CITY OF ALBUQUERQUE

Re: Maher Warehouse, 4120 Culter Ave. NE, Grading and Drainage Plan
Engineer's Stamp dated 05-16-08 (H-17/D086A)

Re: Maher Warehouse, 4120 Culter Ave. NE, Grading and Drainage Plan
Engineer's Stamp dated 04-16-08 (H-17/D086A)

Based upon the information provided in your submittal received 10-30-15, the above referenced plan cannot be approved for Building Permit until the following comments are addressed:

REQUIRED AREA: 6,618.5 GSF

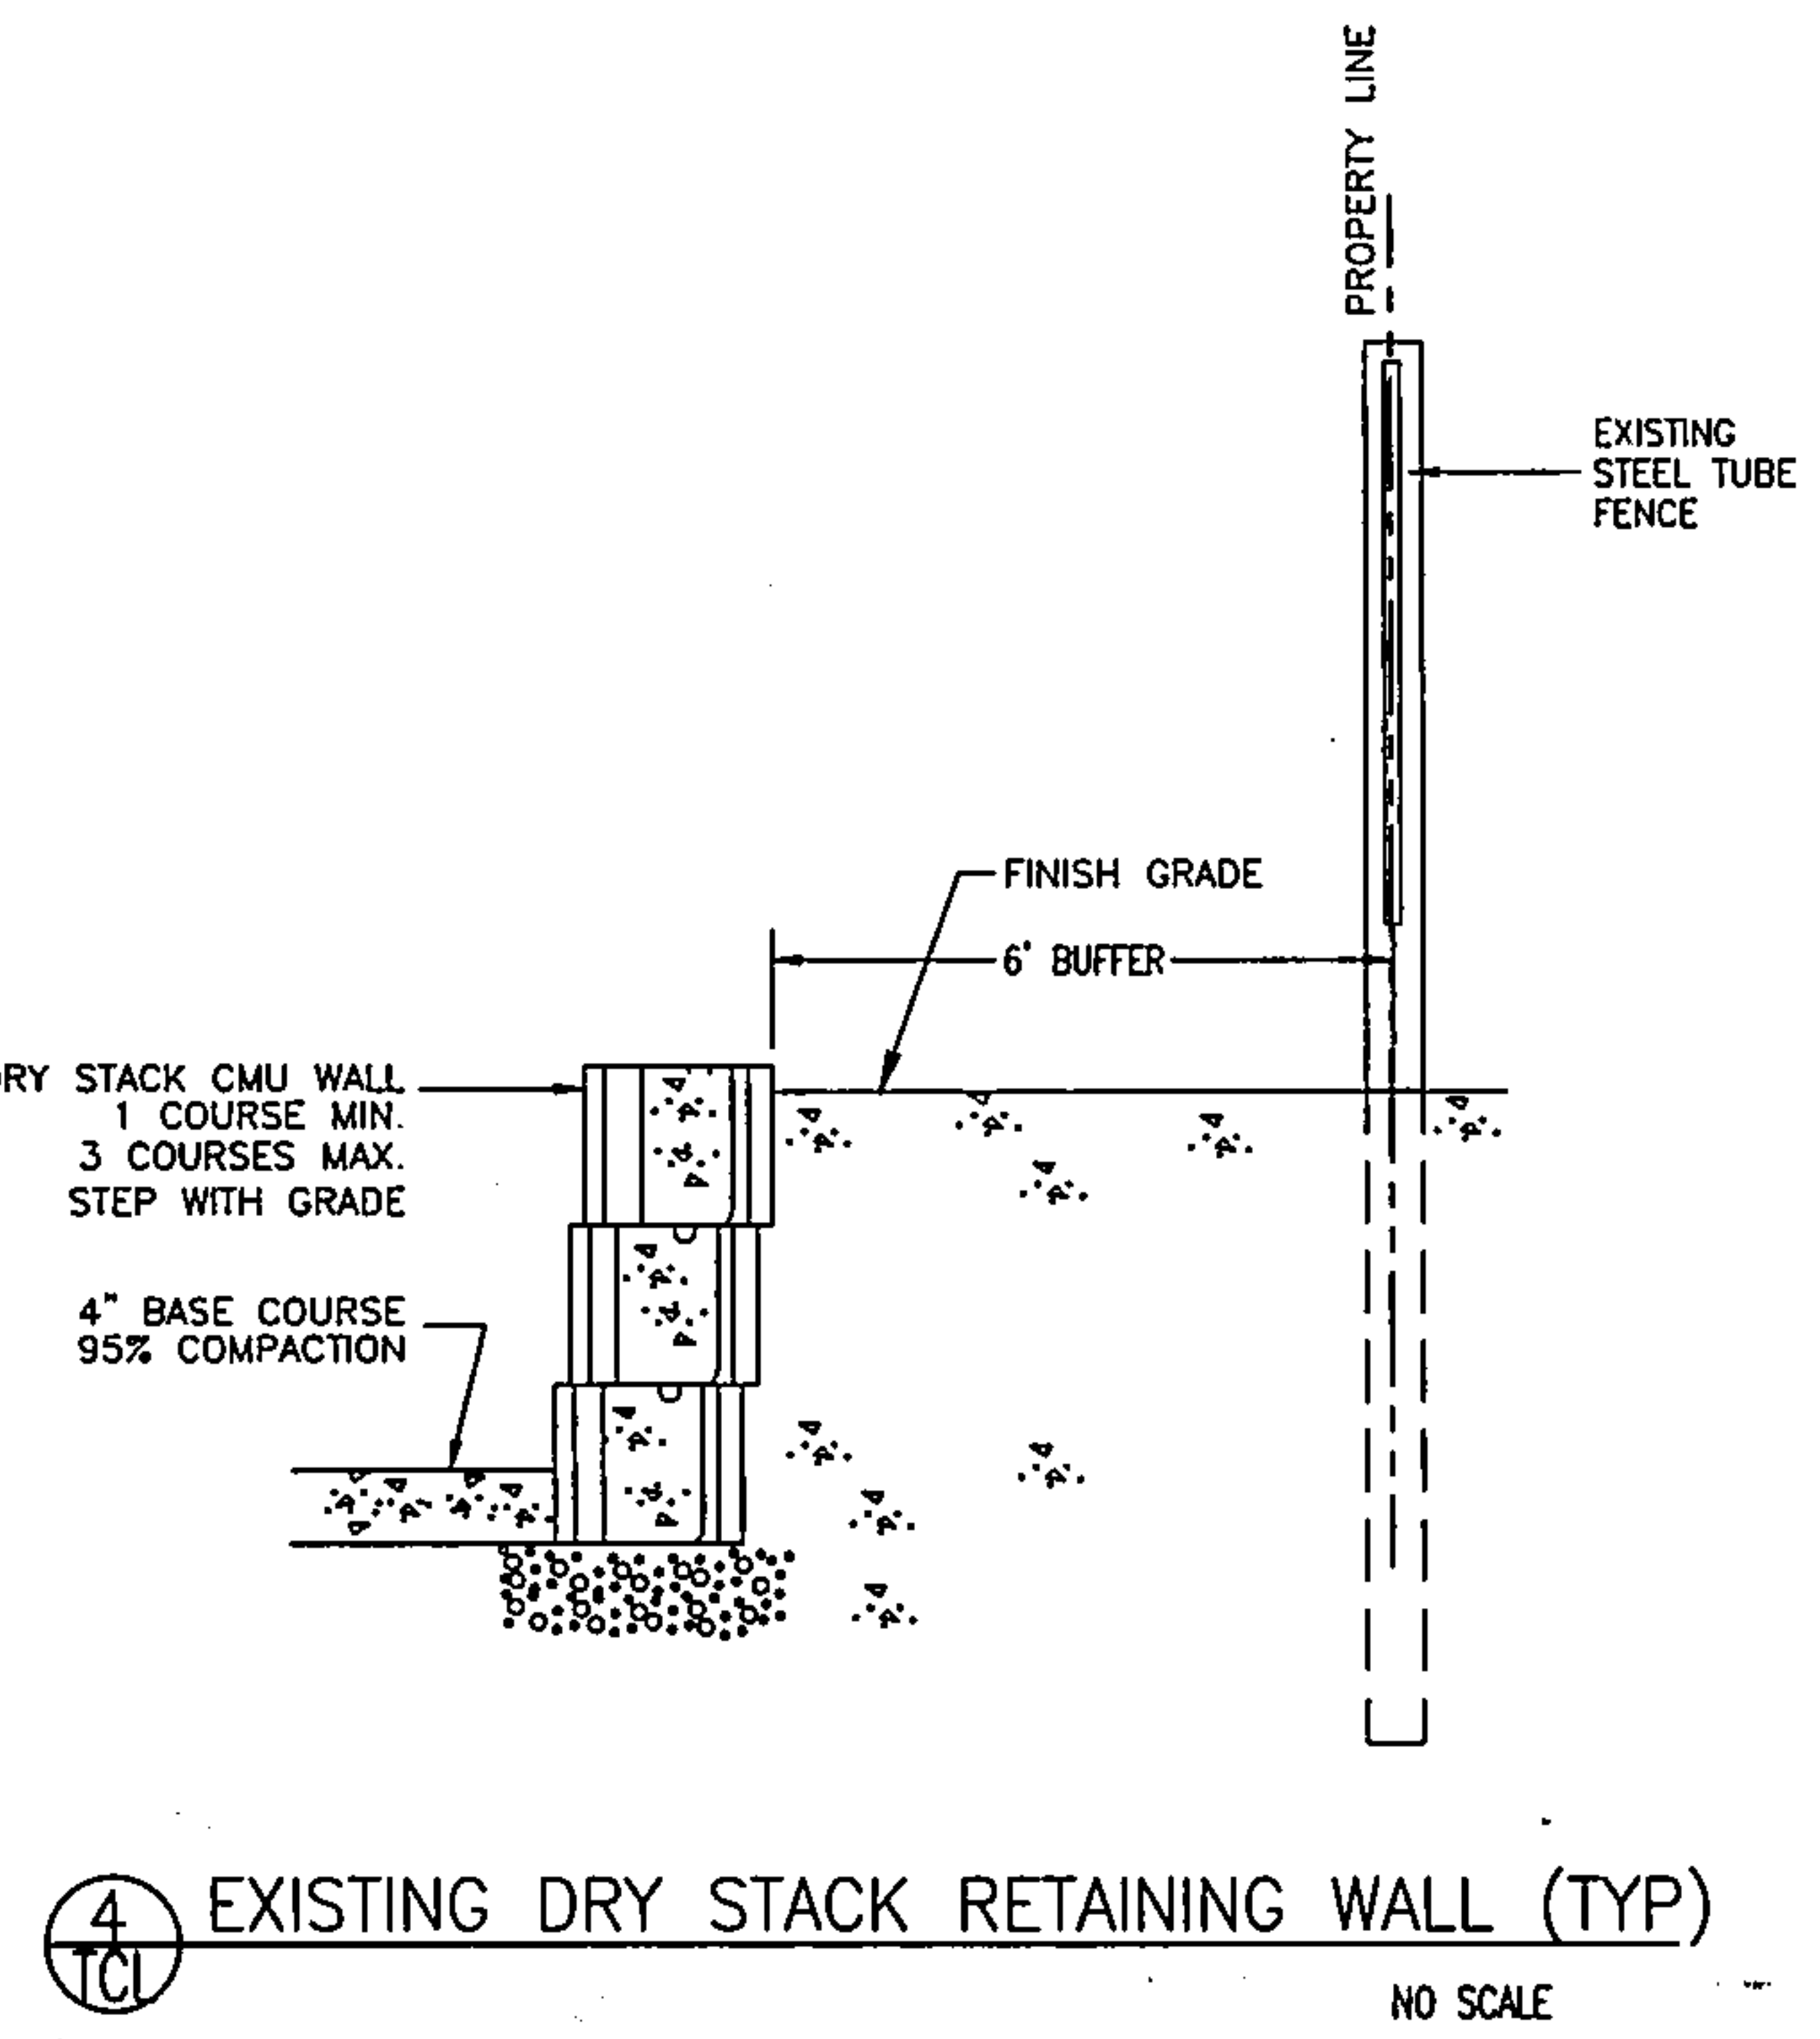
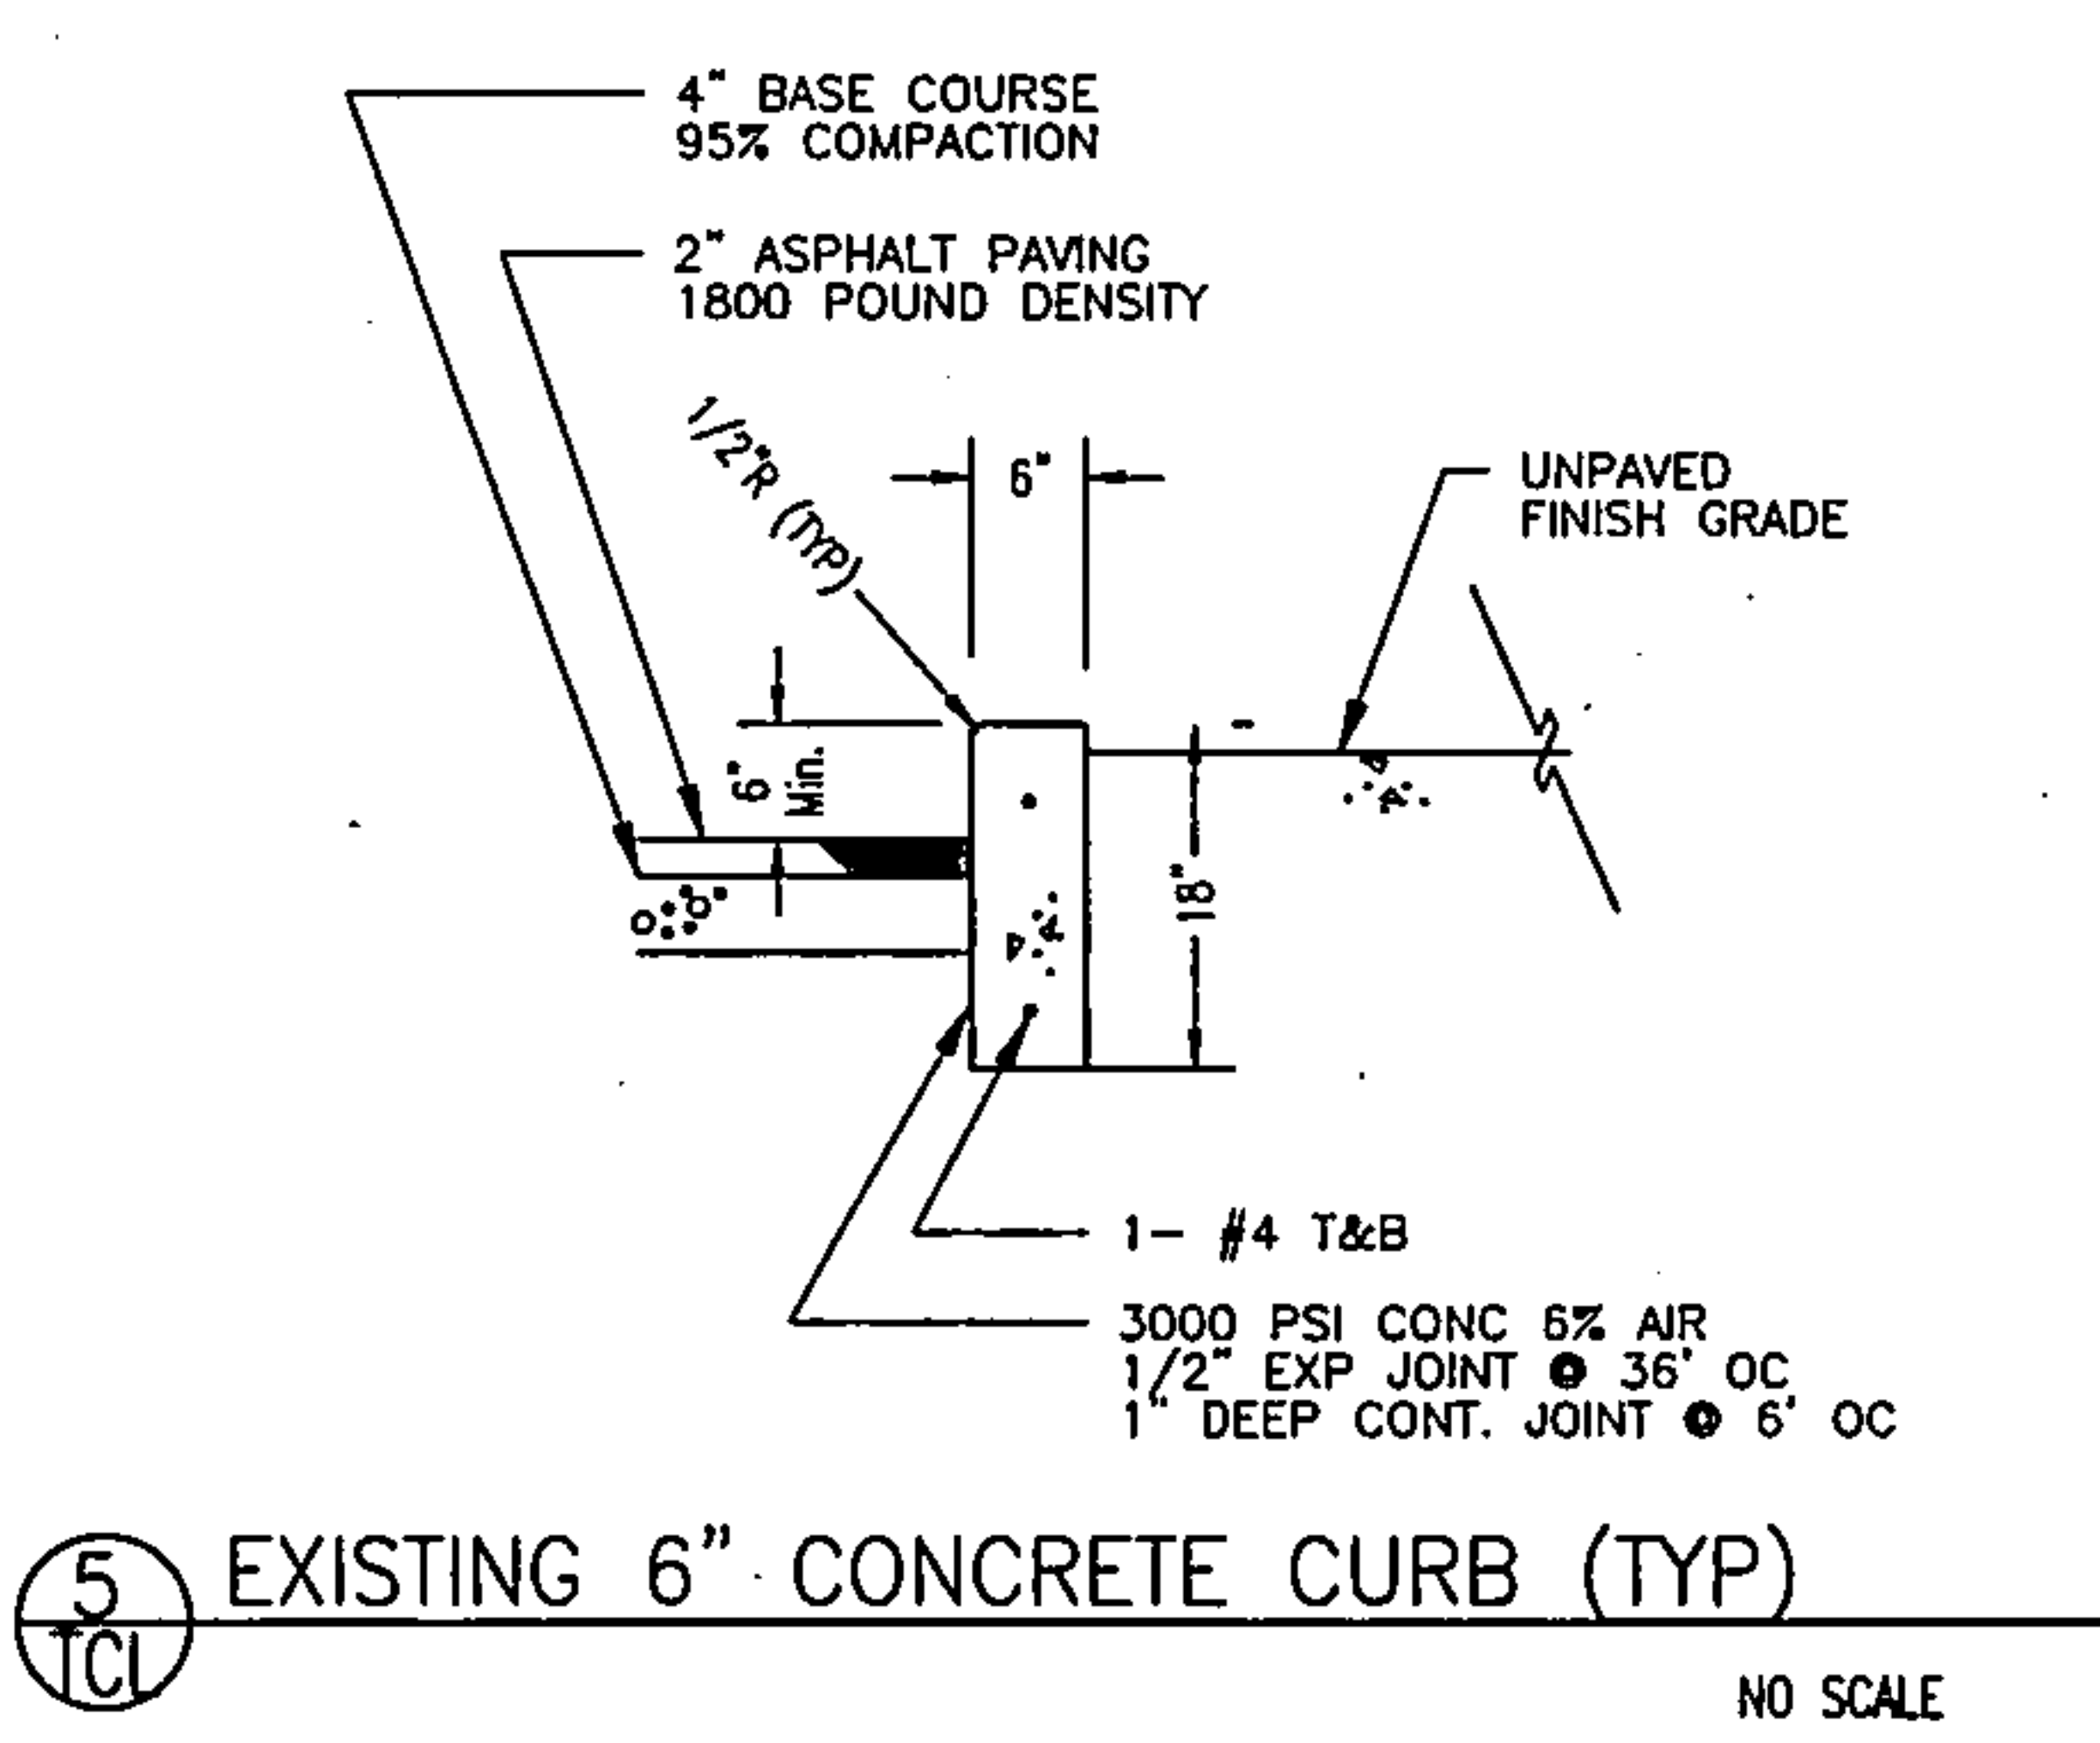
Attached is a marked up drawing of your submittal, notating the ADA sidewalk in question. Per DPM an ADA accessible pathway is required from the public ROW. You are notating that there is a step. Also, the resubmittal will need a new Stamp Date.

** Detail ADA Reg RAMP, specifying slope*
